REMARKS

This response follows the sequence of the Office Action dated 10/14/2004, and, where practicable, is numbered identically.

DRAWING AMENDMENTS

ANNOTATED MARKED-UP DRAWINGS

Fig. 3

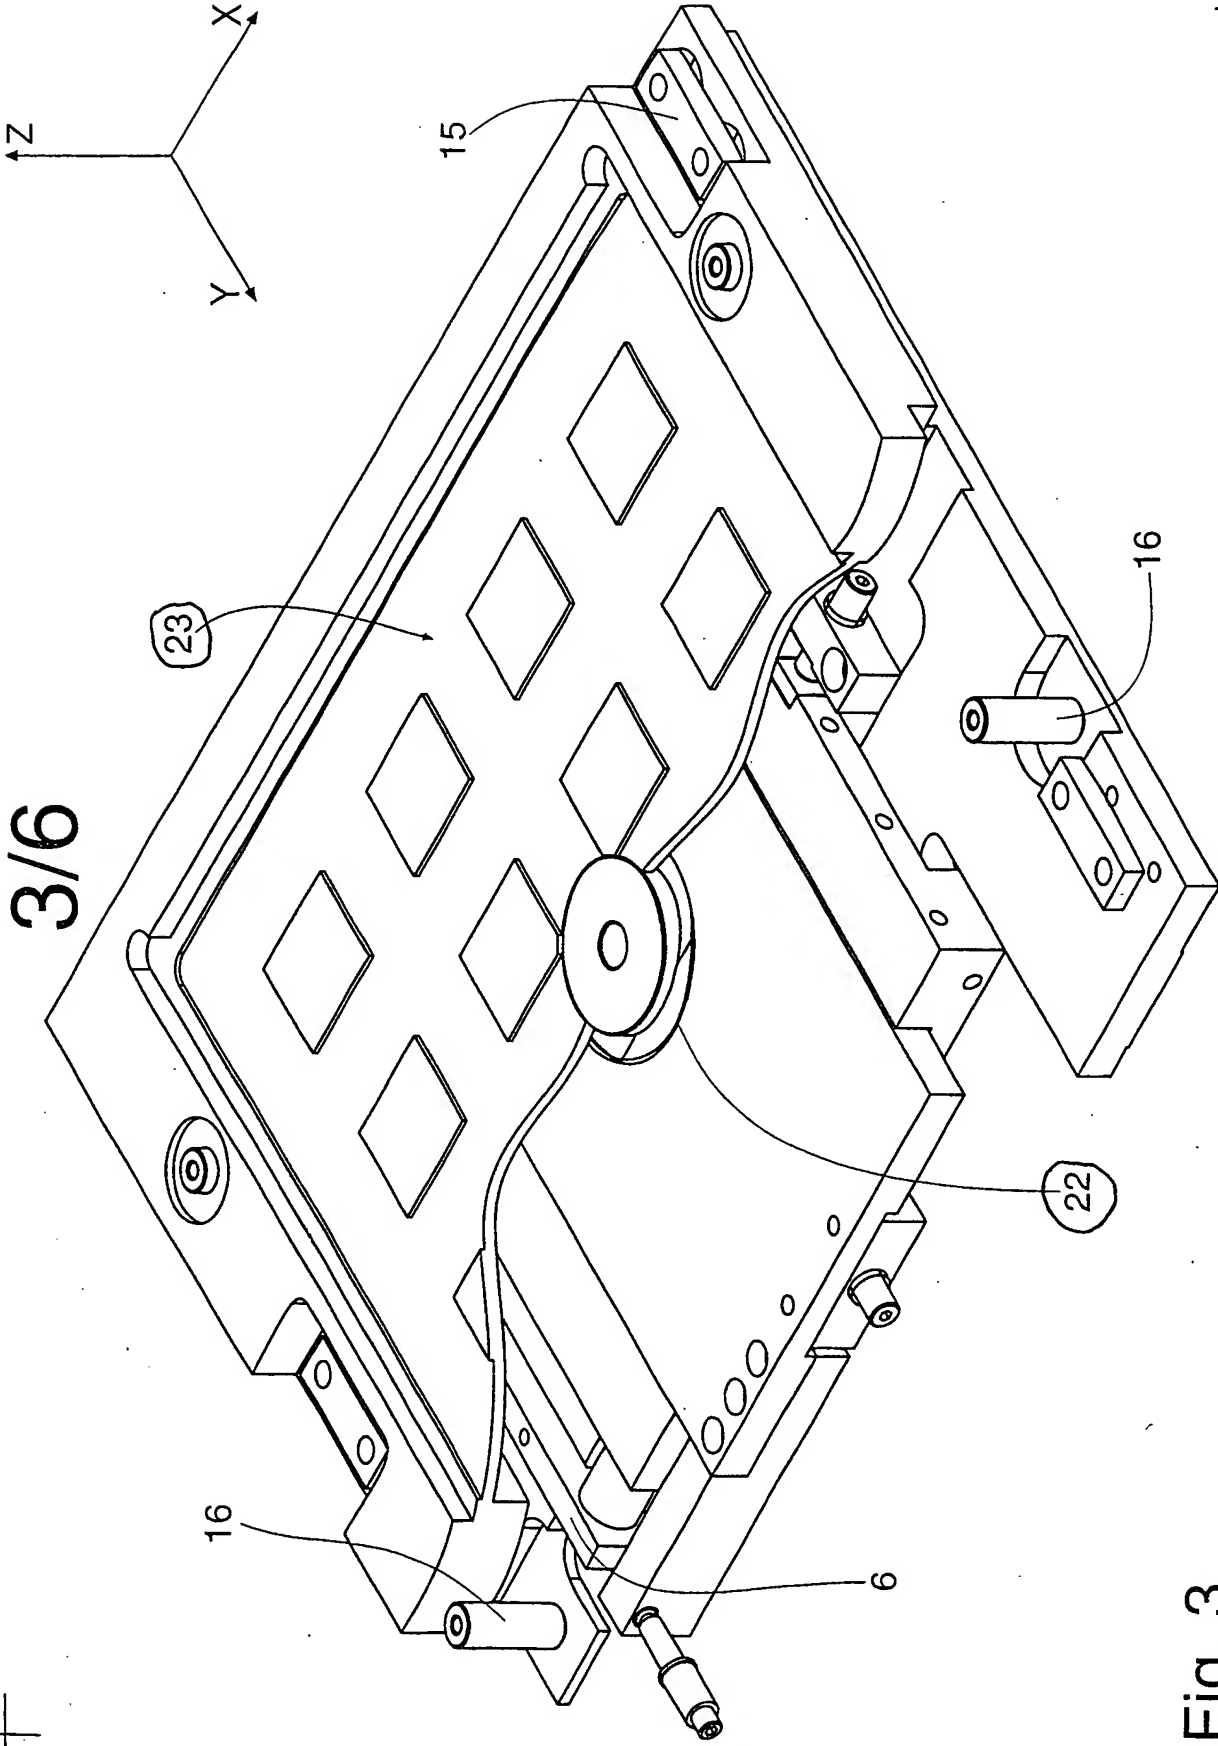
ii. The central yaw shaft opening, which has continuously appeared in Figs. 1-5 as filed, is now identified with reference character 22 in Fig. 3.

Fig. 2

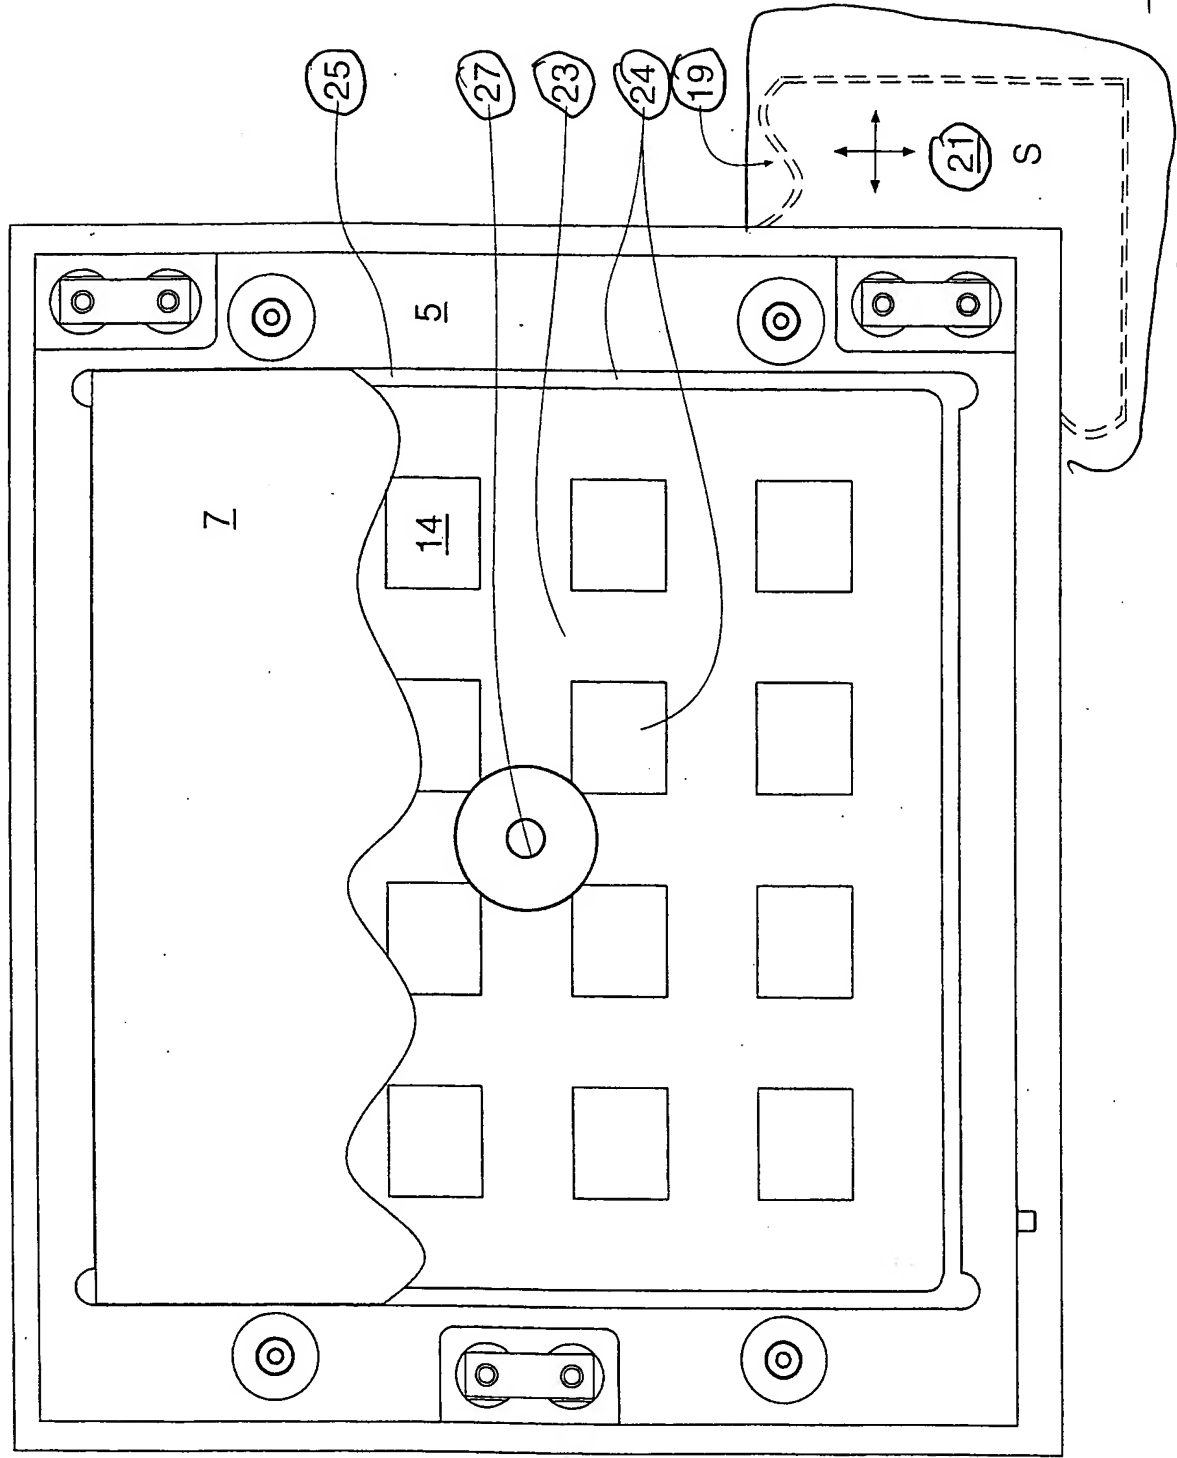
i. A high-resolution stage 19, with its top surface 21 now marked by designation “S,” now appears in Fig. 2. Such high-resolution stages are devices sold as such, and are typically used in microelectronics imaging systems. Note that the high-resolution stage is not positively stated as an element in any claim, but is mentioned in the preamble of claim 1 as context. Another mention, again in context, has been deleted at the end of claim 1. Again in context, the stage is mentioned in several dependent claims where claim features make possible various adjustments of alignment while so mounted. To make clear that the stage is not positively mentioned as an element of invention embodiment construction, but rather mentioned as a mounting location context, the term “such” now is used rather than the confusing term “said.” Counsel apologizes for the confusion.

iii. A vacuum distribution channel pattern has appeared from first filing in Figs. 1 and 2. This vacuum distribution channel pattern is now identified by

reference characters 23 in Figs. 1 and 2. Yaw vacuum diffuser bracket 5 supports vacuum diffuser plate 7 on the tops of diffuser plate support islands 14. Vacuum paths around diffuser plate support islands 14 include representative channels in vacuum channel pattern 23 shown in Figs. 1-3. .

viii. Epoxy cement is now shown as smears 24 atop representative positions of the peripheral vacuum diffuser plate locating relief 25 diffuser plate support island among the archipelago of such islands including diffuser plate support island 14 in Fig. 2.

All drawing corrections are included in the substitute sheets 1, 2 & 3 of drawings, which the Examiner is asked to approve. Except for the addition of the precision stage 19 and its surface 21, shown in dashed lines as context (not positively stated as an element in any claim) in Fig. 2, all changes are additions of reference numerals to identify items already shown in the figures and already referred to in the text. These changes place the patent application in full compliance with all rules requiring placement and identification in the figures of items previously described elsewhere in the written description and claims – thus no “new matter.”
